## LINCOLN/LANCASTER COUNTY PLANNING STAFF REPORT

**P.A.S.:** Change of Zone #3329  
Special Permit #1928  
Oak Creek Apartments C.U.P.

**DATE:** September 19, 2001

CHANGE OF ZONE EXHIBIT  
I-1 TO R-3 RESIDENTIAL

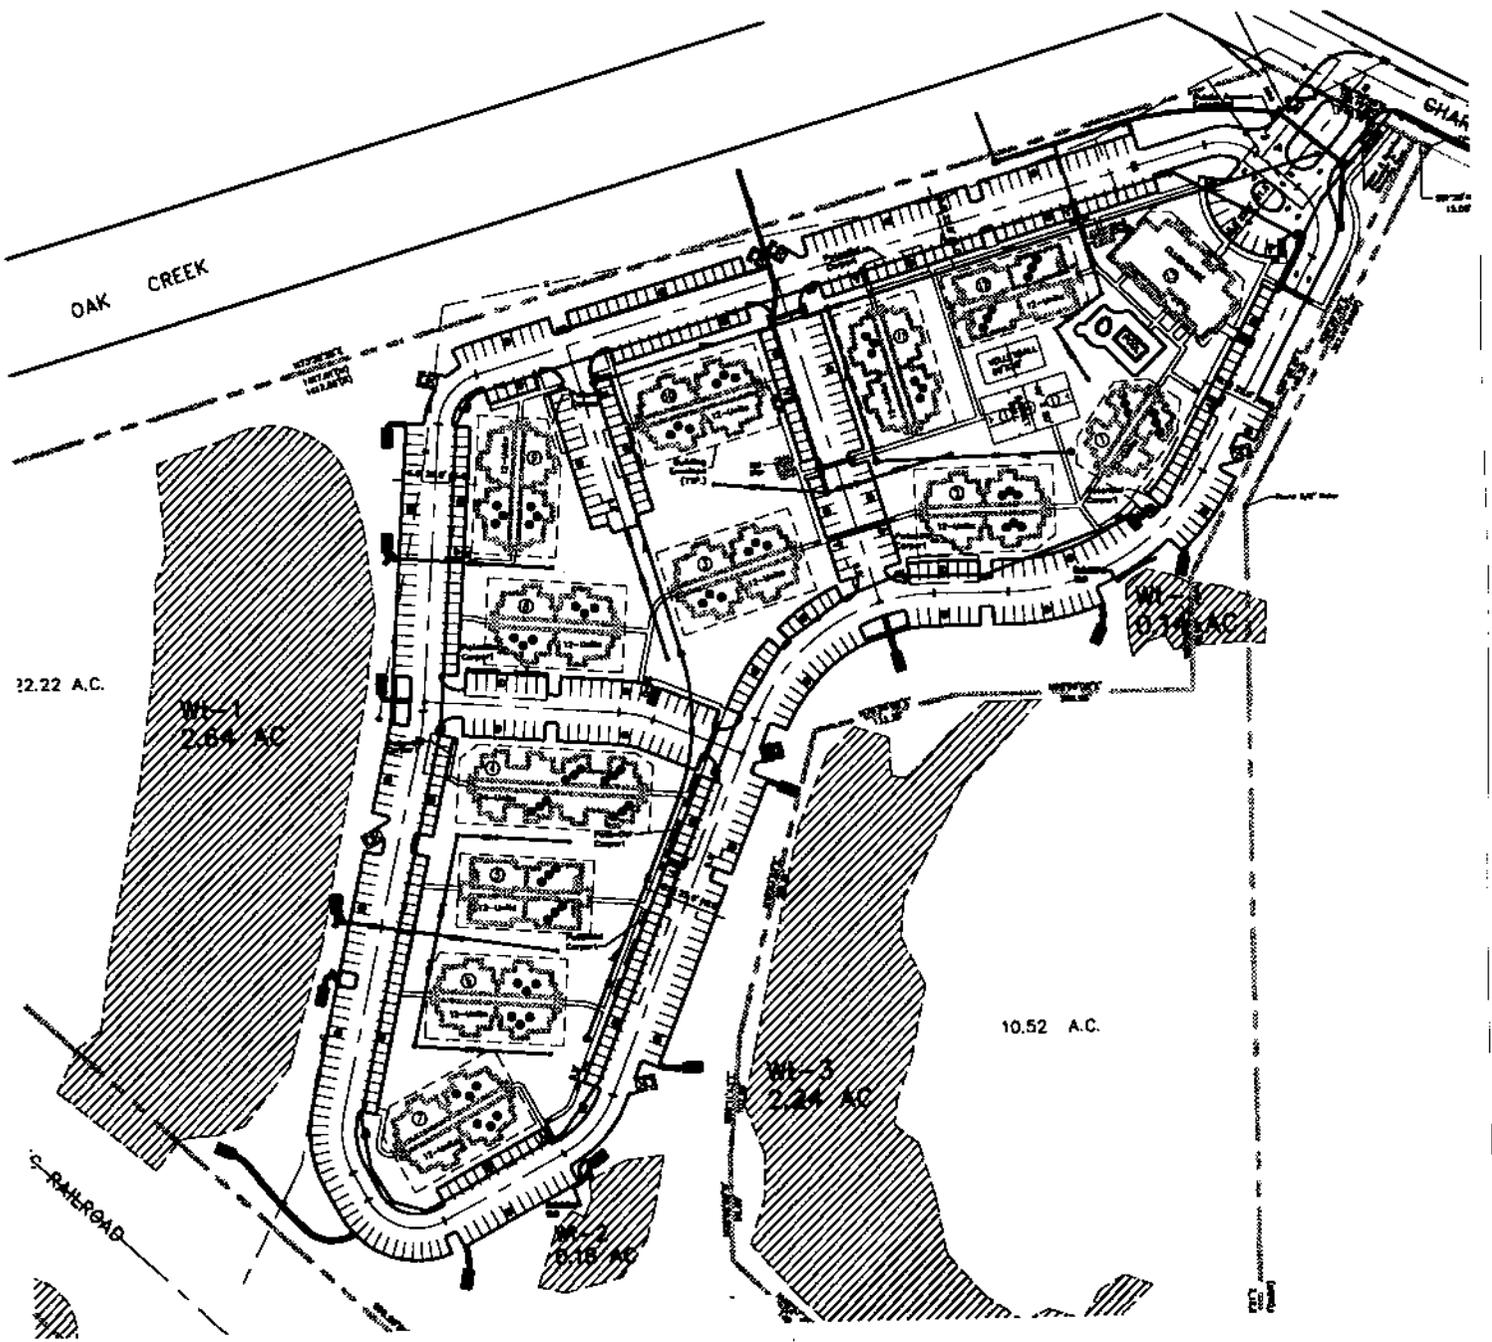
**PROPOSAL:** Change of Zone #3329 Amend the zoning map west of N. 1<sup>st</sup> Street and Charleston from I-1 Industrial to R-3 Residential

Grading Plan REI 09-20-01

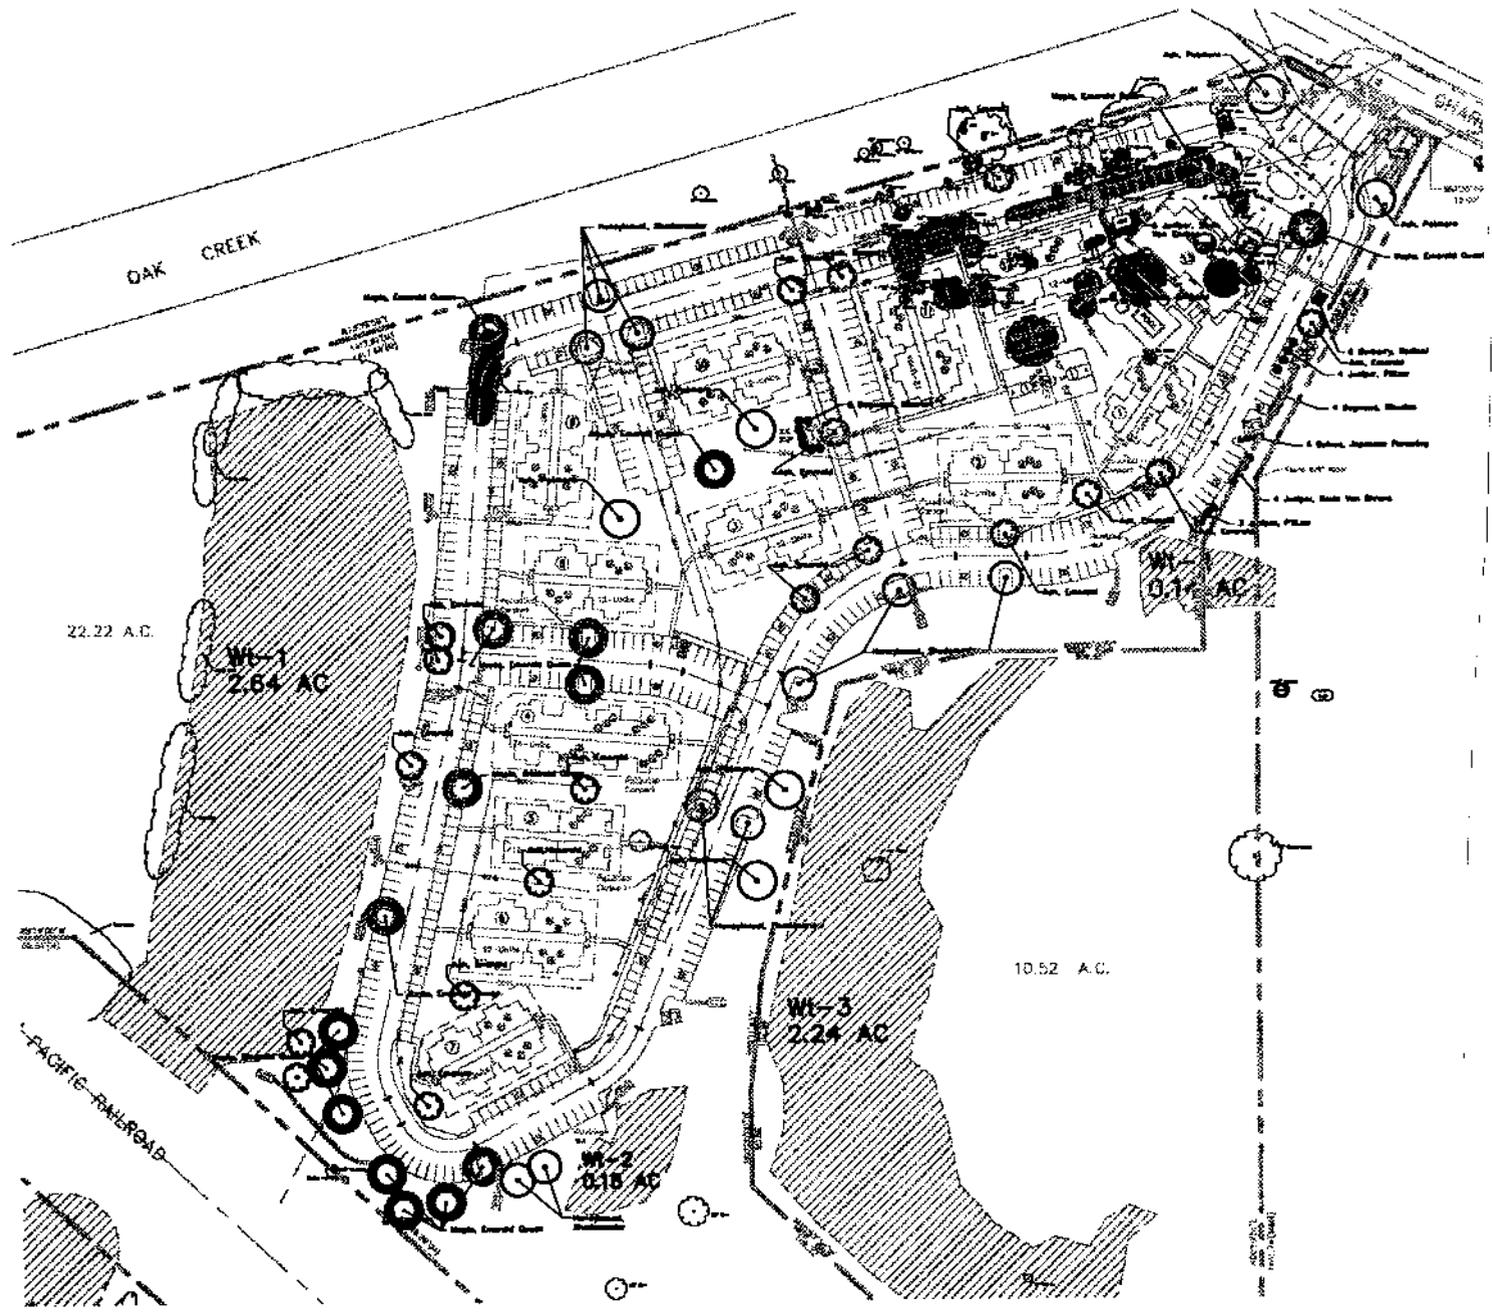
The proposed C.U.P. does not fill any of the existing wetlands on site. According to the Grading Plan, 30,483 of 32,146 cubic yards of fill will be borrowed on-site. Lincoln’s current flood plain regulations do not require that any fill be borrowed on-site.

- 1.2 Revise the site plan to show:
  - 1.2.1 Correct the fill amount in note 1 of the Grading Plan.
  - 1.2.2 Indicate the required setbacks around the perimeter of the site.
